RE: PCN # ESU270-43 – SP1064-04UTG alternative backend location approval

PCN#: ESU270-43 Date: March 15, 2019 Product Identification : SP1064-04UTG TVS Diode Array Product alternative backend location approval Implementation Date for Change: June 14, 2019 or sooner	Contact Information Name: Jia Zhu Title: Product Marketing Manager Phone # : +86 13913131571 Fax# : N/A E-mail : jzhu3@littelfuse.com
--	---

PCN Report

8.0 Changed Part Identification:

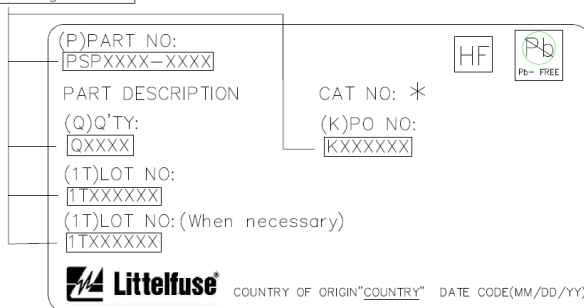
There are qualified suppliers, detail please refer to below table

Package Type	Part Number	Original	New added
DFN2510-10L	SP1064-04UTG	M	G

And it can be identified by code of CAT NO on the label.
